TOWN PLANNING APPLICATION

PROPOSED MIXED-USE DEVELOPMENT AT

9 BROWN STREET PORTARLINGTON

Project
MIXED USE DEVELOPMENT
9 BROWN STREET
PORTARLINGTON

Drawing Title
LEVEL 2 FLOOR PLAN
Scale
1:100 @ A1
Date
24.02.2023

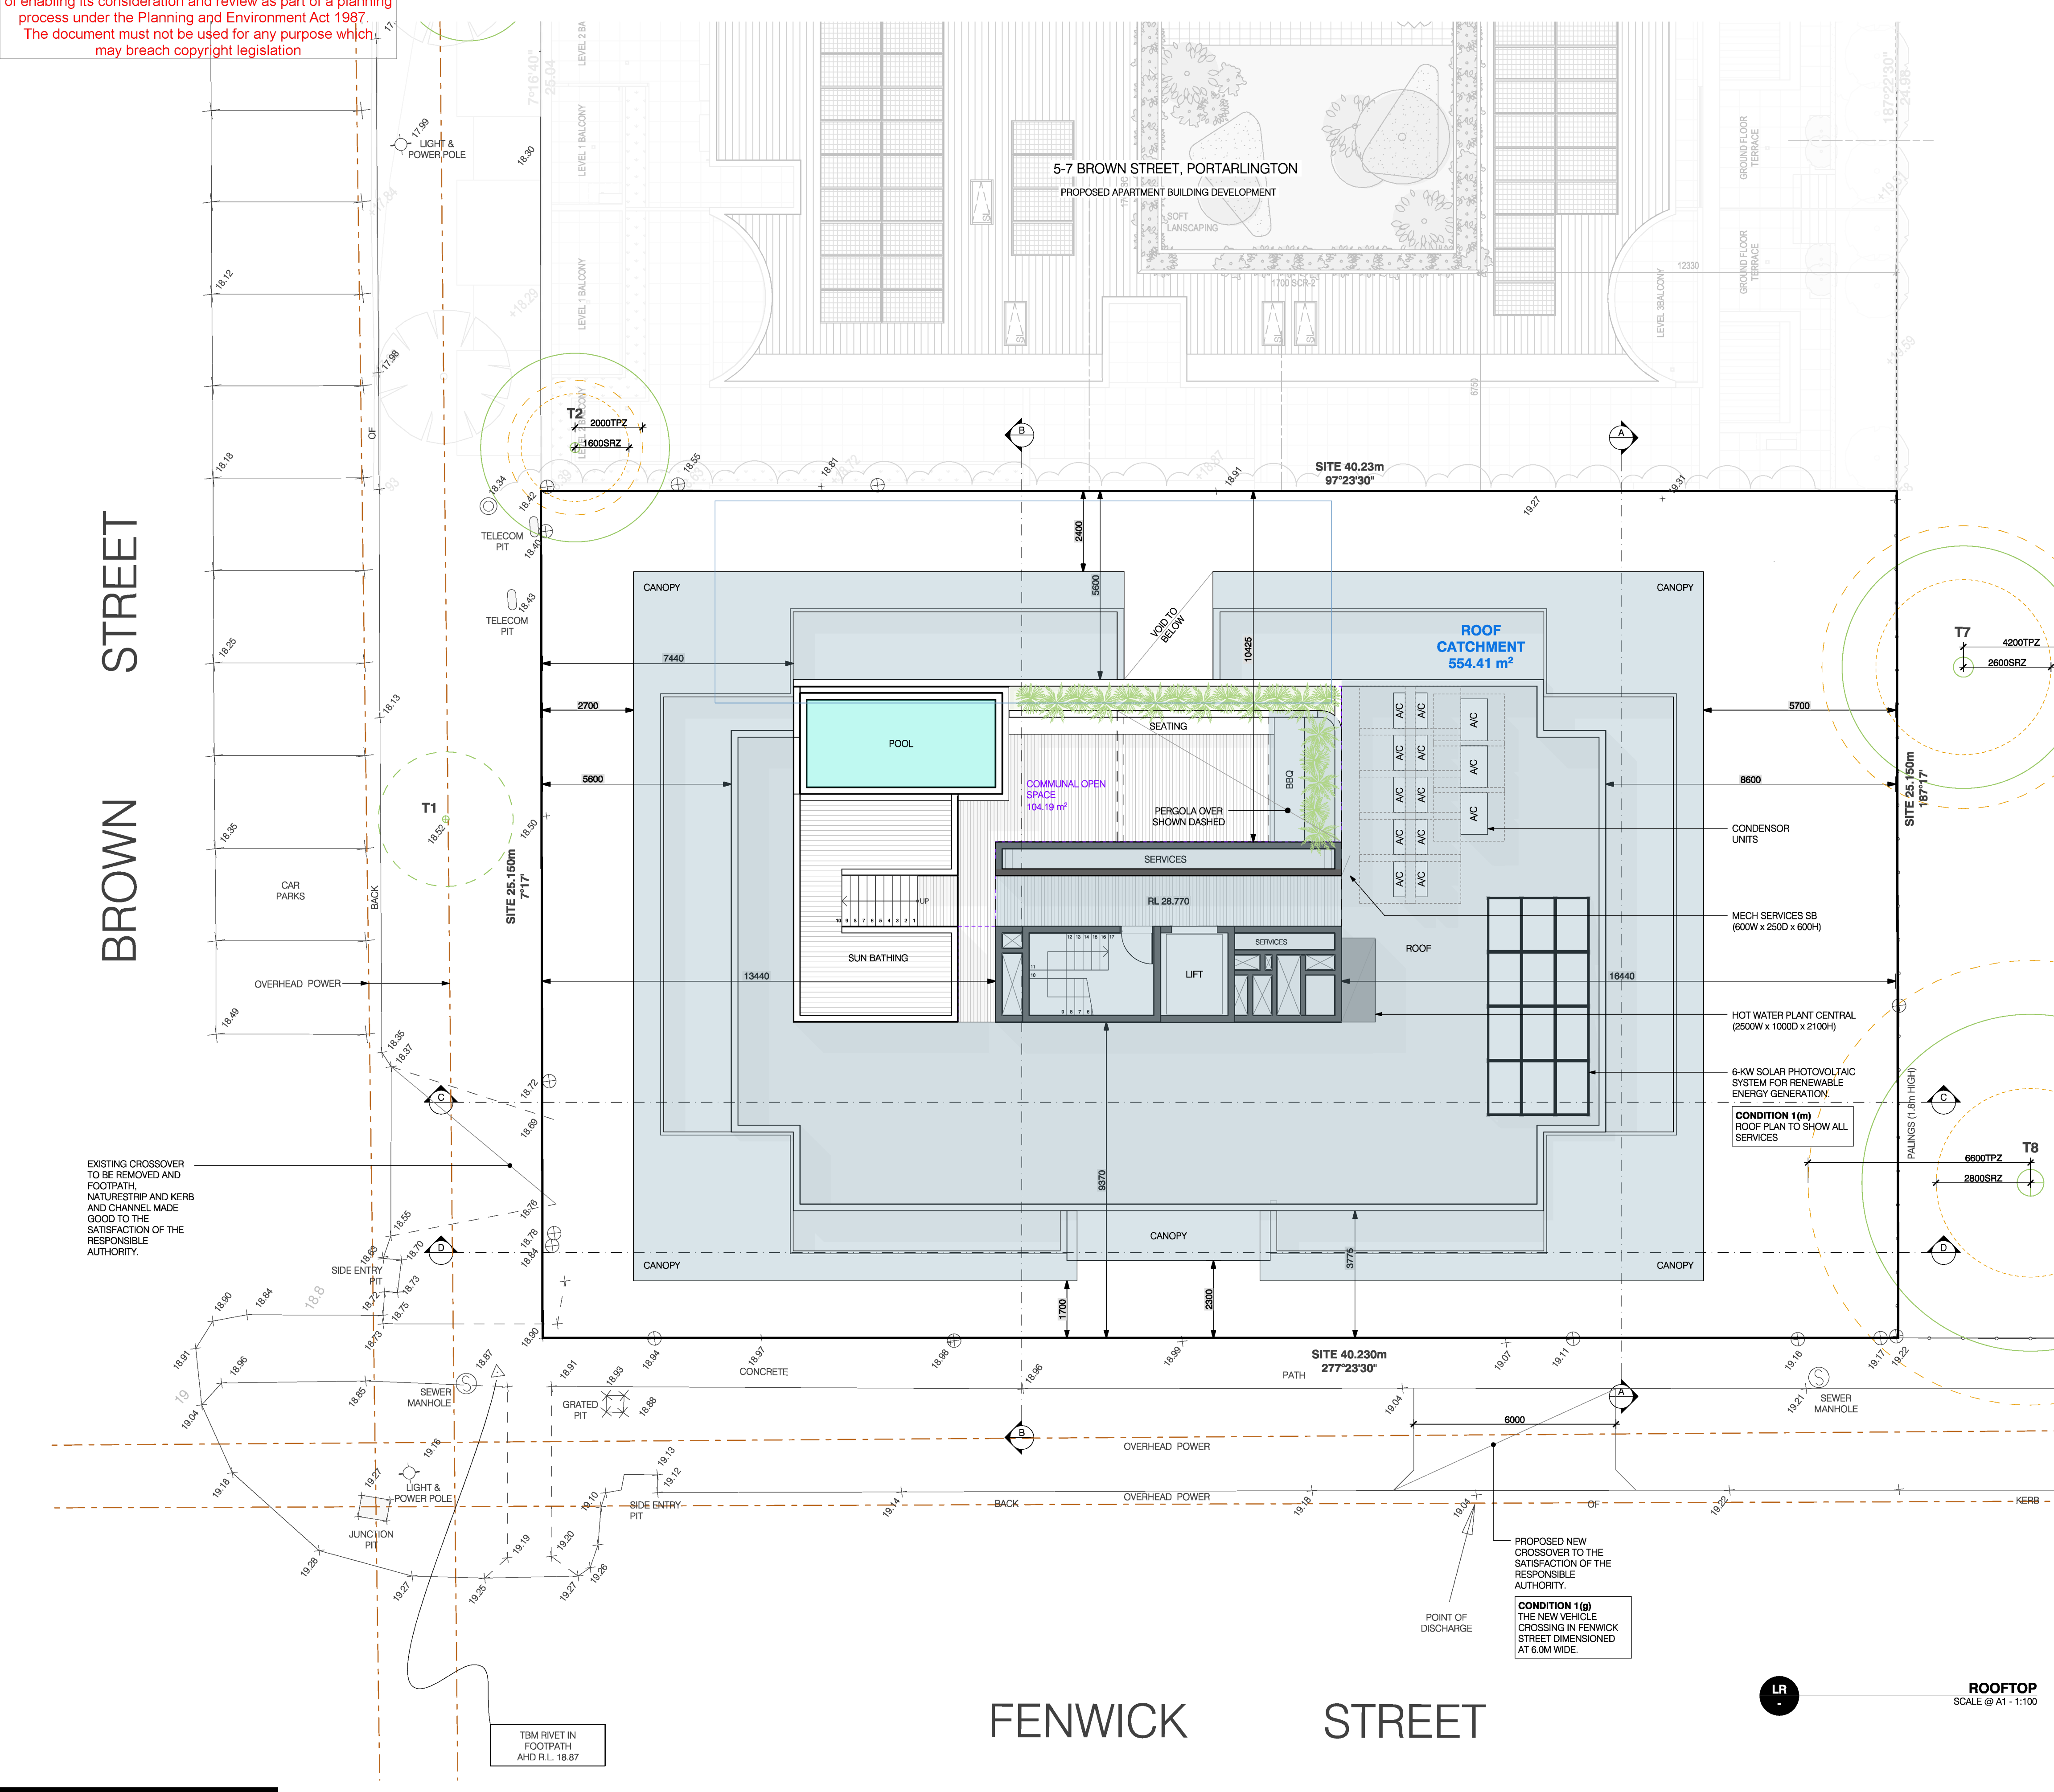
CONDITION 1(n)
SET BACK THE NORTHERN EXTENT OF THE BALCONIES FOR APARTMENTS 2.01 AND 2.05 WHERE ADJACENT TO THE BEDROOM WINDOWS, A MINIMUM OF 1.5m FROM THE NORTHERN BOUNDARY MAINTAINING THE PLANTER BOX.

CONDITION 1(n)
PERMANENT FIXED SCREENING DEVICES WITH NO GREATER THAN 25% TRANSPARENCY TO ALL NORTH FACING BEDROOM WINDOWS ON LEVEL 2 (THIRD STOREY) WHERE THE SILL HEIGHT IS LESS THAN 1.7M ANY SCREENING DEVICES SHOULD BE DESIGNED TO ACHIEVE ANGLED VIEWS OUT TO THE NORTH WEST AND NORTH EAST. CONSIDERATION OF ESD PERFORMANCE IS ALSO REQUIRED AS PART OF THIS SCREENING.

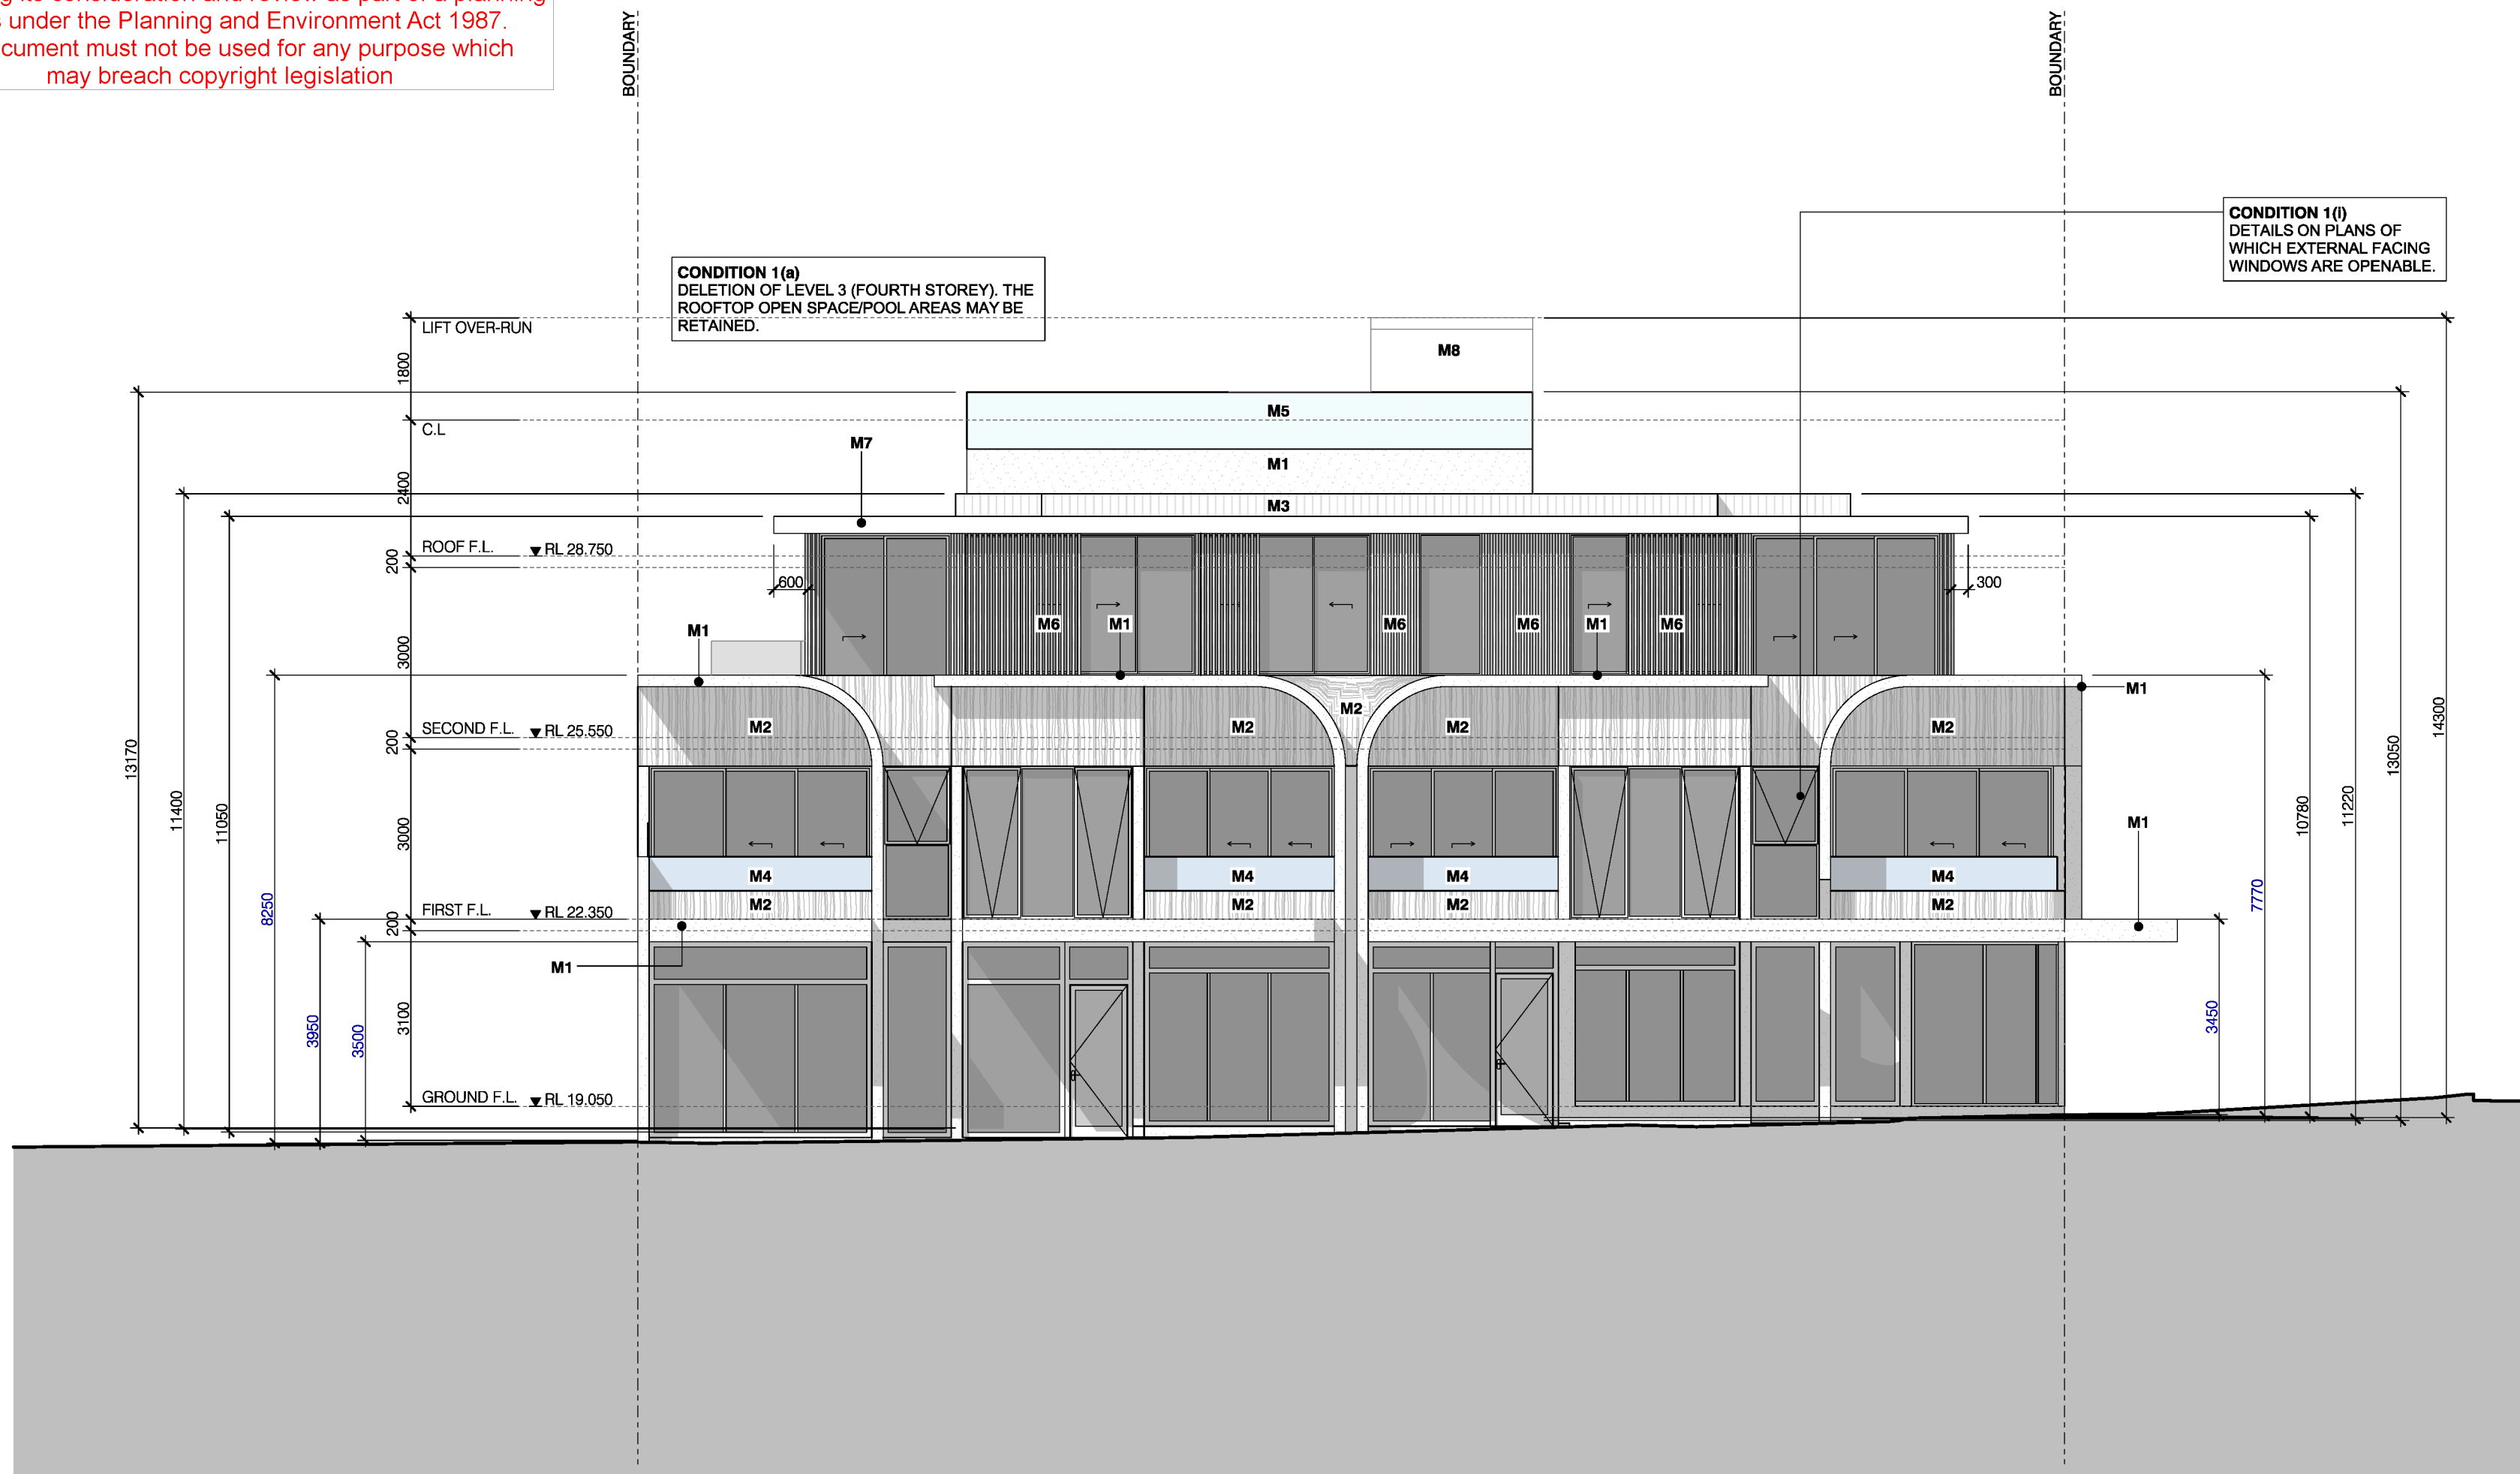
CONDITION 1(d)
ANY CHANGES AND RECOMMENDATIONS OF THE ESD REPORT (SMP) REQUIRED BY CONDITION 6.

CONDITION 1(e)
ANY CHANGES AND RECOMMENDATIONS OF THE BESS REPORT REQUIRED BY CONDITION 5.
